**STAFF RECOMMENDATION**  
**421 Broadway**  
**September 20, 2017**

**Application:** New construction, Illumination, and Signage-violations  
**District:** Broadway Historic Preservation Zoning Overlay  
**Council District:** 19  
**Map and Parcel Number:** 09306310800  
**Applicant:** Good Times, LLC  
**Project Lead:** Paul Hoffman, paul.hoffman@nashville.gov

421 Broadway, Sept 5, 2017

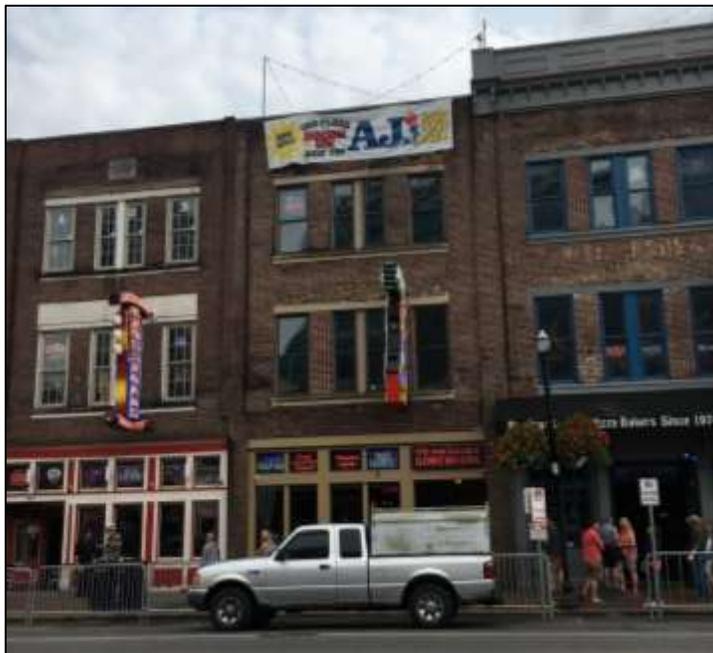
**Analysis and Findings:** The applicant requests approval of new construction-additions and illumination added to the rooftop that includes string lighting and poles attached to the railings (see figures 1 and 2) and a neon wall sign added above the entrance.

**New Construction-additions:** The rooftop addition was initially built as approved, with its front wall set back more than thirty feet (30’) from the front wall of the building, in accordance with the district design guidelines. Recently the business installed poles with

string lighting attached. (See figures 1 and 2.) New construction should step back from the front wall at least thirty feet (30') to ensure that new construction is not “visually jarring or contrasting” and that it is “minimal” compared to the historic building. Permanently- installed features forward of the thirty foot (30') set back do not meet the design guidelines. A similar request was disapproved in the August Commission meeting for 423 Broadway. The project does not meet section II.H of the design guidelines for New Construction-additions.

Illumination: The design guidelines call for lighting to be “simple and unobtrusive in design, materials and relationship to other façade or elevation elements.” String lighting and the requisite poles for installation of the lighting (see figure 2) are not appropriate in the stepback area as it is highly visible and the addition should be subordinate to the historic building. In addition, lighting is allowed for illumination of the façade, (II.T.2) not for defining outdoor spaces.

**Recommendation:** Staff recommends that the unpermitted signage (wall sign and vinyl banner), string lighting and poles be removed within 30 days, finding the project does not meet section III.H for Additions, Section II.T. for Lighting, nor Section IV for Signage.

Rooftop area at 421 Broadway

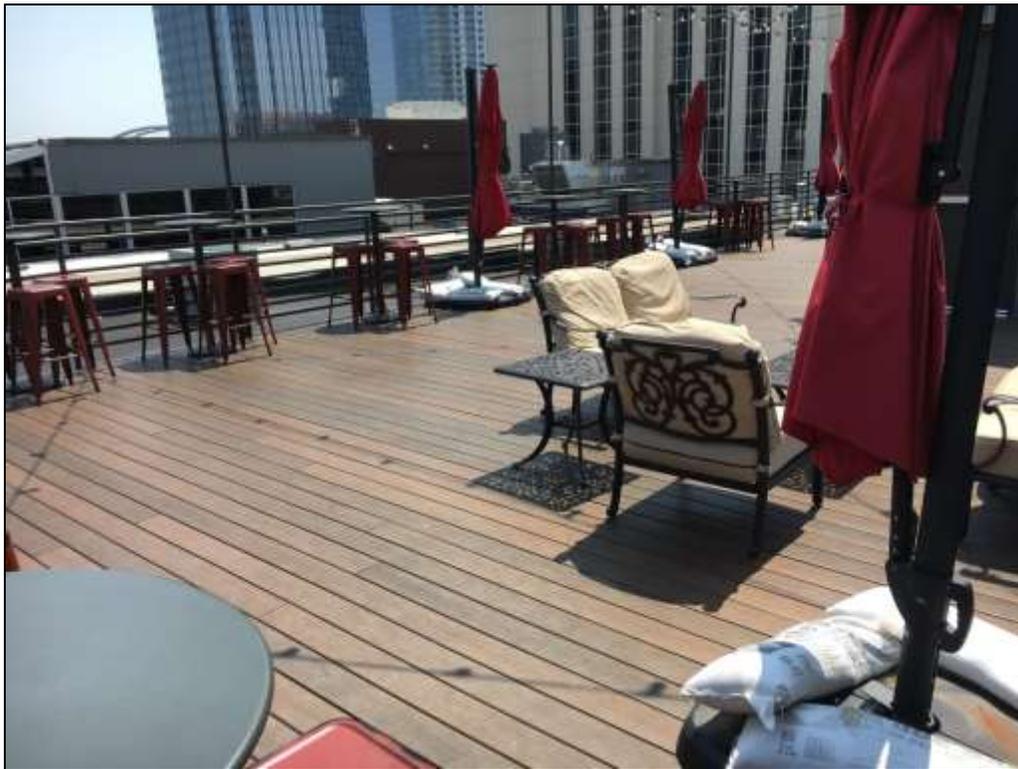
Staff recommends non permanently-installed lighting such as electric table candles or bollard lighting that does not extend above the parapet. Since the applicant has not applied for alternatives, the recommendation is for disapproval rather than approval with conditions. The project does not meet section II.T for Lighting.
